Access Compliance Report

Public Rights-of-Way

(Curb Ramps)

Intersection ID: 14127	Main Street: BASCOM_ST	Cross Street: BAY_ST	Location: NW
ADA ID: 69E27052D752	Ramp Type: Perp	Initial Pass/Fail: Fail	Overall Compliance: No
Severity Score: 10			
Codes/Mitigation Info/Possible Solution		Field Measurements/Component Compliance

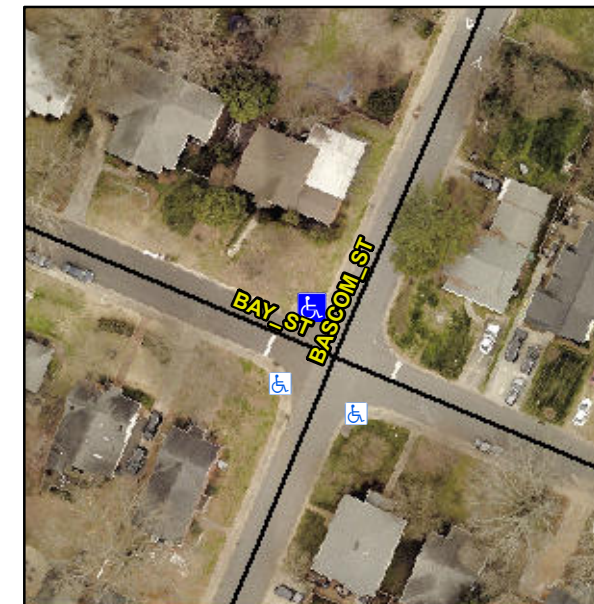
R304.5.1, R304.5.3

Compliance	Description	Data	Compliance	Description	Data
N/A	Ramp Length (in)	60.0	Yes	Ramp Slope (%)	6.7
No	Ramp Width (in)	47.0	No	Ramp XSlope (%)	3.6
N/A	Flare Type LT	N/A	N/A	Flare Type RT	N/A
N/A	Flare Slope LT (%)	N/A	N/A	Flare Slope RT (%)	N/A
N/A	Flare Traversable LT?	N/A	N/A	Flare Traversable RT?	N/A
N/A	Landing Length (in)	N/A	N/A	DWS Provided?	N/A
N/A	Landing Width (in)	N/A	N/A	DWS Contrast?	N/A
N/A	Landing Slope (%)	N/A	N/A	DWS Length (in)	N/A
N/A	Landing X Slope (%)	N/A	N/A	DWS Full Width?	N/A
N/A	Landing Curb? (Y/N)	N/A	N/A	DWS Offset (in)	N/A
N/A	Shared Landing?	N/A			
N/A	Gutter Ponding?	Yes	N/A	Gutter Slope (%)	N/A
N/A	Gutter Lip Ht (in)	0.5	N/A	Gutter X Slope (%)	N/A
N/A	Painted X Walk1?	No	N/A	Painted X Walk2?	N/A
	X Walk 1 Direction	To SW		X Walk 2 Direction	N/A
N/A	X Walk 1 Width (in)	N/A	N/A	X Walk 2 Width (in)	N/A
	X Walk 1 Slope (%)	4.2		X Walk 2 Slope (%)	N/A
	X Walk 1 X Slope (%)	0.5		X Walk 2 X Slope (%)	N/A

Remove & Replace Entire Ramp.
